TOWN OF UNDERHILL

Development Review Board

JASON MARIAS
SKETCH PLAN REVIEW
Docket #: DRB-20-02

Project Proposal: Sketch Plan Review of Jason Marias for a proposed re-subdivision of a previously approved 3-Lot Subdivision of property located at the aforementioned address. The Applicant is proposing to add an additional lot, subdividing the previous lot identified as Lot 1 in Exhibit G into two lots.

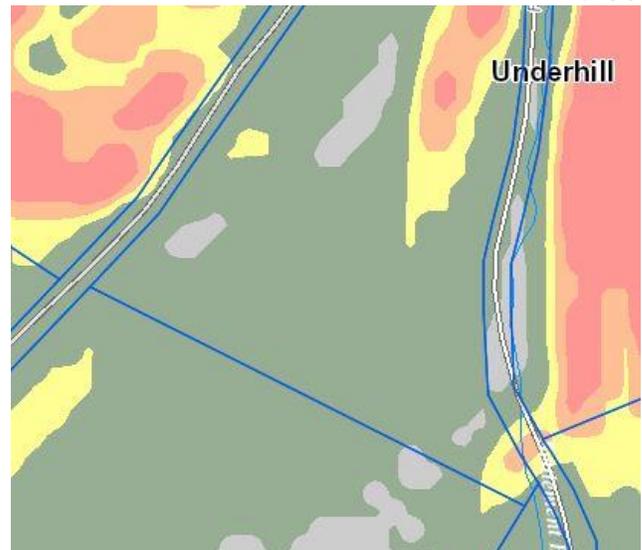
- Areas of steep slopes (15-25%) are present on the existing lot (see directly to the right).
- While some areas of steep slopes will be present on the proposed Lot 1A, development is not anticipated in those areas, and therefore, additional review under this section will not be required so long as the Applicant does not submit future plans impacting those areas.
